**March 10, 2014**  
**Medway Planning and Economic Development Board**  
**155 Village Street**  
**Medway, MA 02053**

This is an informal site plan pre-application meeting re: Tri-Valley Commons.

**"TRI VALLEY COMMONS"**

"SITE LAYOUT"  
 PLAN OF LAND  
 IN  
**MEDWAY, MA**

SHEET TITLE  
**SCHEMATIC COLOR ELEVATIONS**  
JOB NAME  
**Bldg. "A" (Goodyear)**  
TR-VALLEY COMMONS  
MEDWAY, MASSACHUSETTS

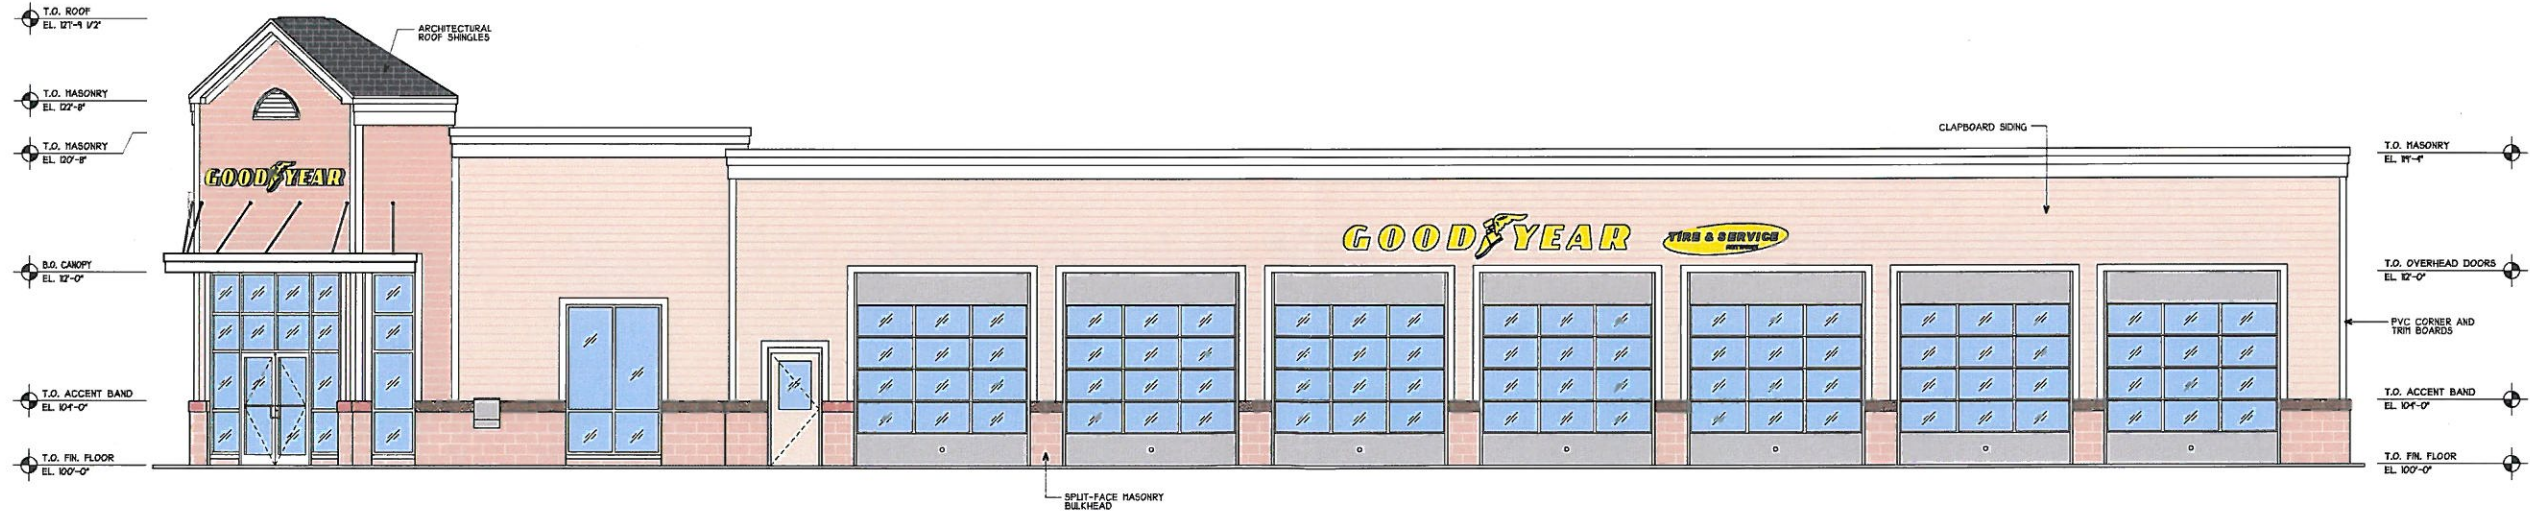
Rachel Walsh asked what is the difference between the parking area compared with the Rt.109 project. The corner building needs to be more architecturally developed since it is visible on the corner. The eastern side is shown as a blank wall and trellis, this needs to have treatment to it. This is not an invisible side. Making it a village feel, this is a good idea, but having advance auto and Goodyear tire, make them look village and not industrial with shingles, etc. Get rid of the metal roof. It has an industrial look not New England.

Matt Buckley responded that he likes the idea of reusing the stones as part of the landscape features. He also wants to see rendering of the wall and also the materials. He wants more precise drawings with the four sides of the buildings. Another aspect which needs to be looked at are the signs which need to be in compliance with the sign bylaw.

Susy indicated that Advance Auto can have two signs and Goodyear Tire can have three.

The beginning will be on natural ground and will grade up. Will be level with Rt.109. The applicant can add treatment to the building. They will add treatment to the main buildings. The materials can be changed to match the New England design.

**FRONT ELEVATION**

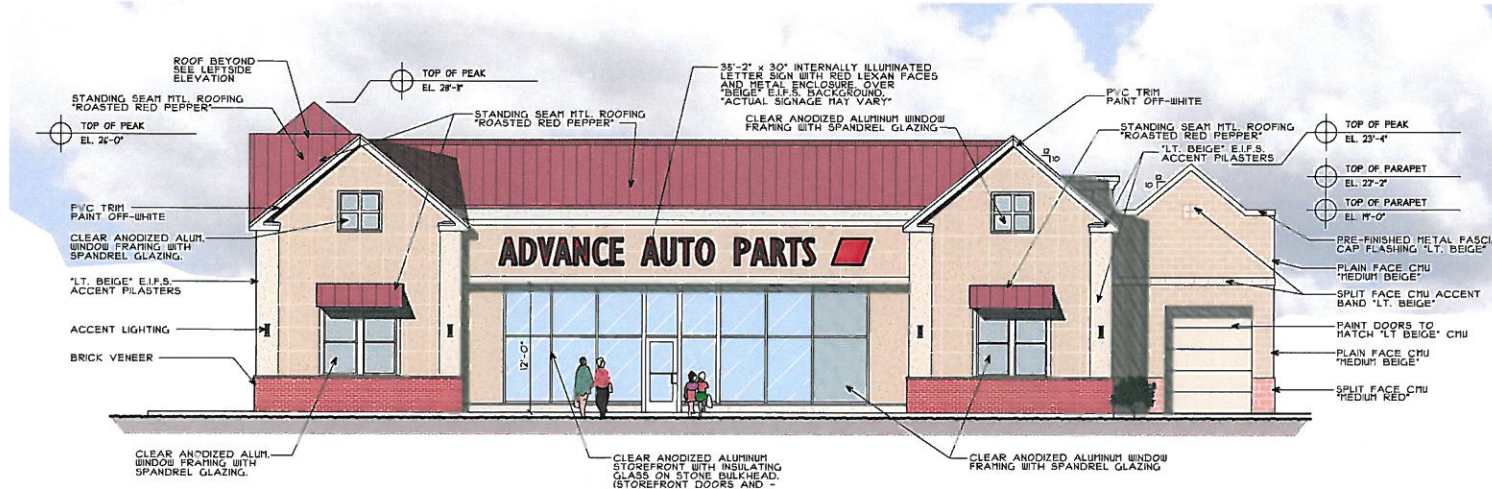
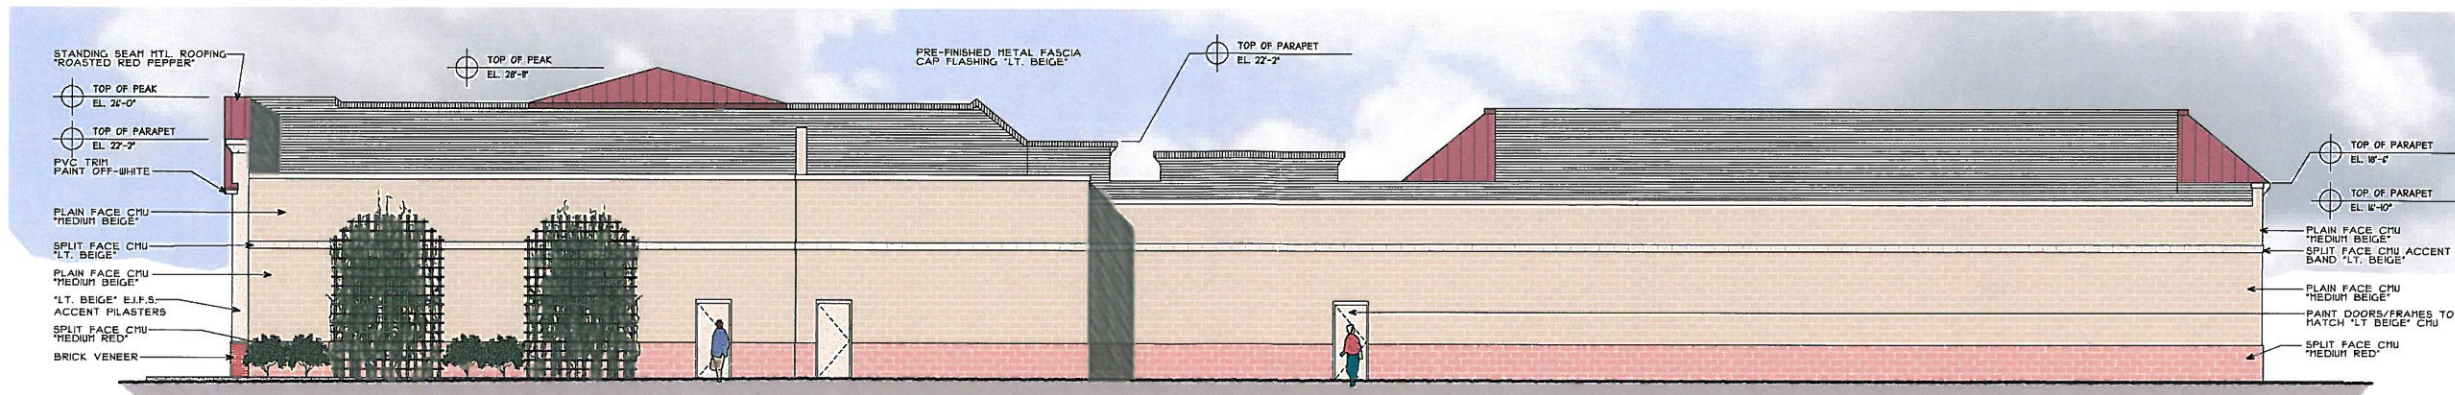
(FACES ROUTE 69A)  
 NOTE: ZONING BYLAWS ALLOW ONLY (1) SIGN PER TENANT IN A MULTI-TENANT PROJECT.  
 SIGN SHOWN WILL REQUIRE A VARIANCE.
